Fwd: Planning Application for 1 Coleridge Way (Ref: 6160/APP/2019/3638)

Subject: Planning Application for 1 Coleridge Way (Ref: 6160/APP/2019/3638)

We have been appointed by the London Borough of Hillingdon (LBH) to undertake validation checks on planning applications submitted to them. We are currently validating the above application, and would advise your current planning application has been made invalid for the following reasons:

FIRST FLOOR PLAN AS PROPOSED

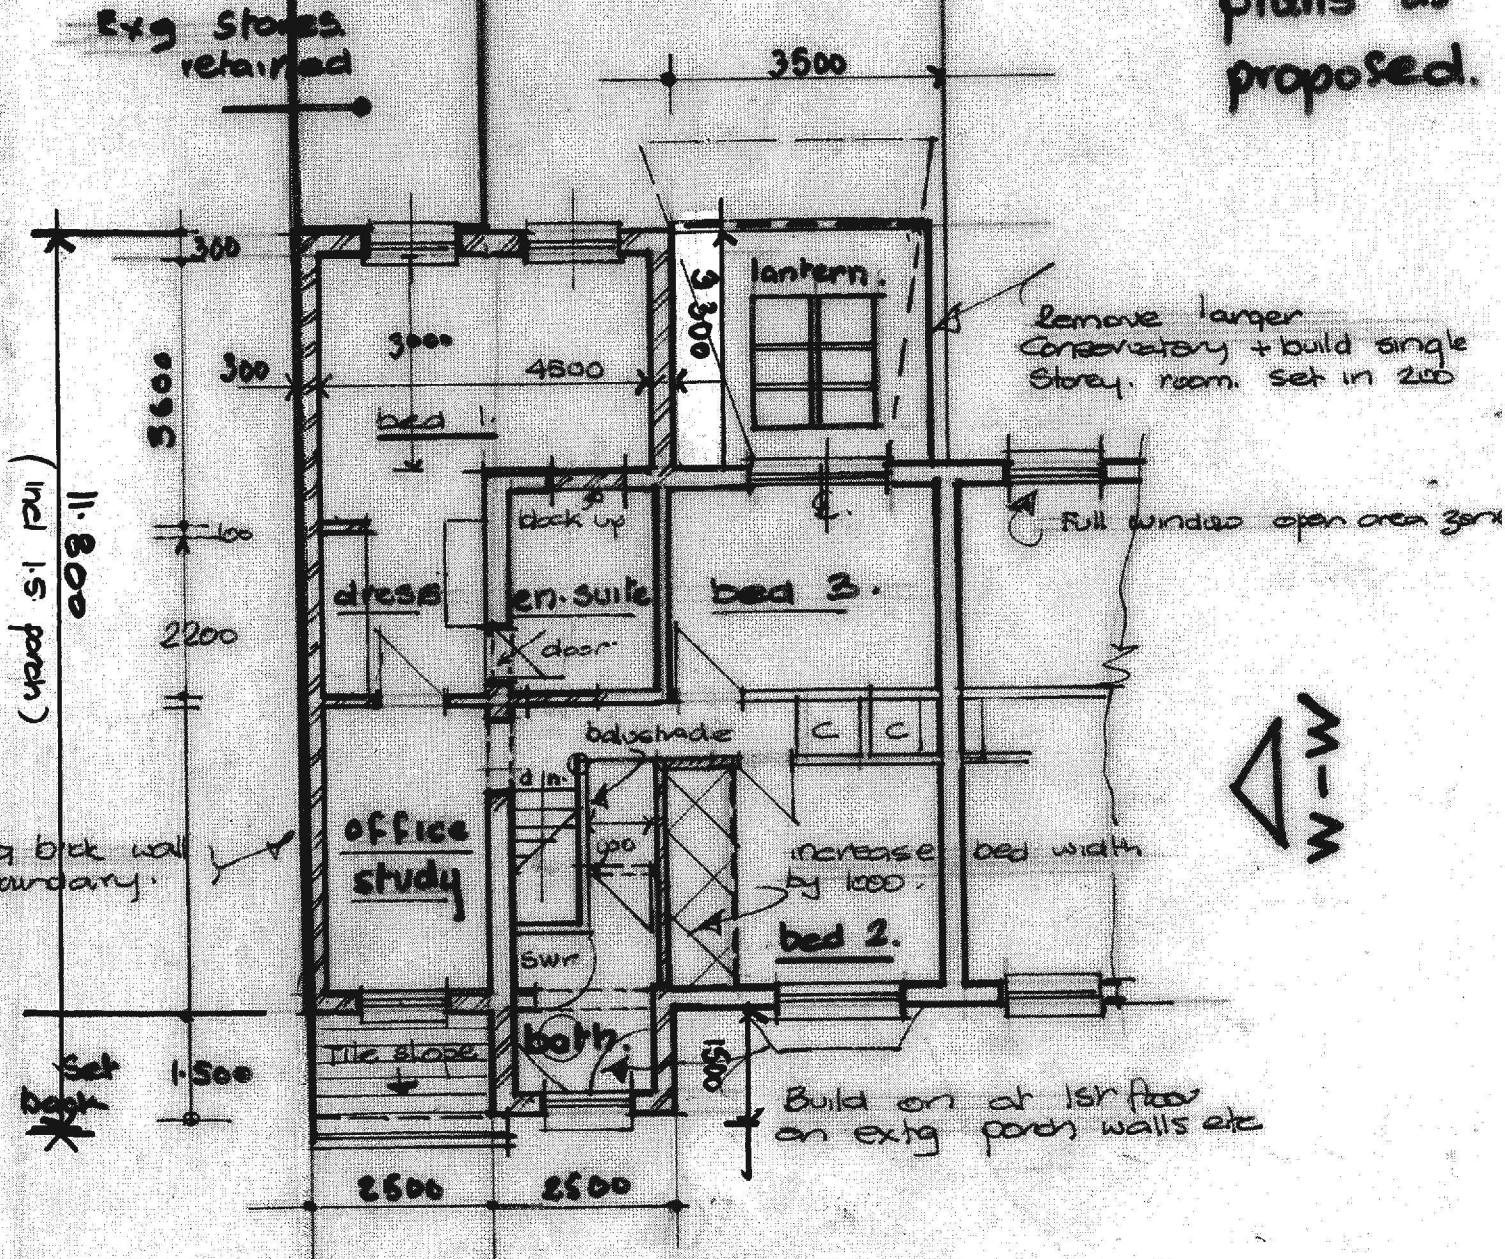
2. Plans Inconsistent: The window is inconsistent between the proposed first floor plan and east ✓

elevation. Please review and amend accordingly.

Amended plans.

Dwg ICW. E. 14.19.2.

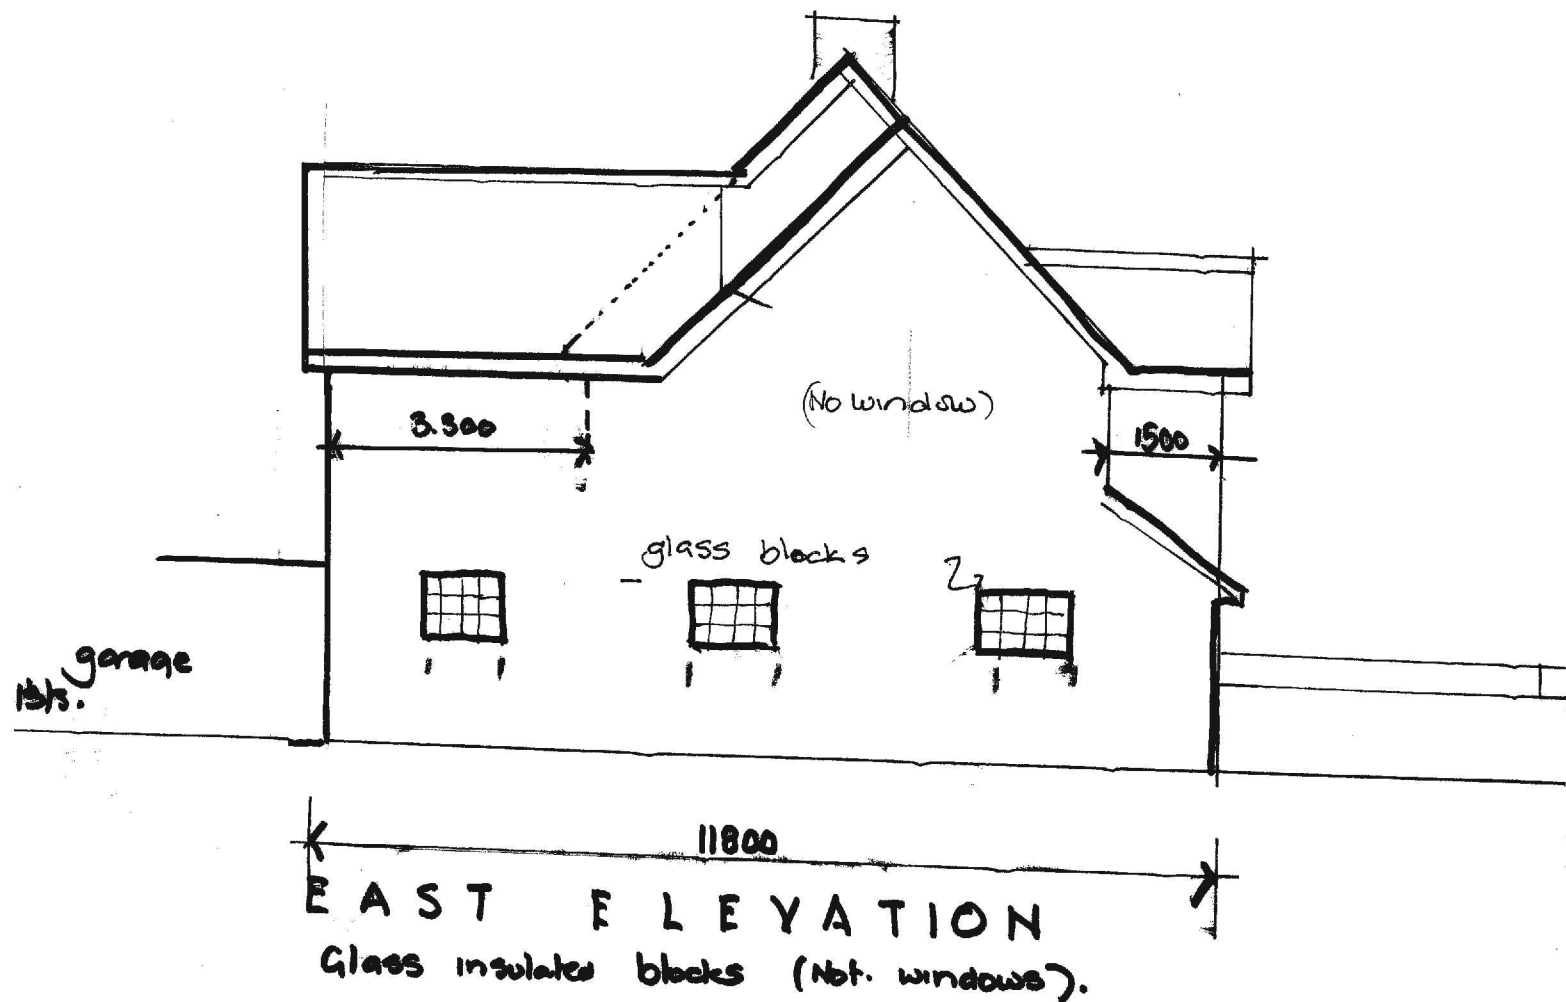
1. Plans Inconsistent: The depth of the extension is inconsistent between the floor plans and east elevation. Please review and amend accordingly; ✓

- (1) East elevation plan accords
with floor plan
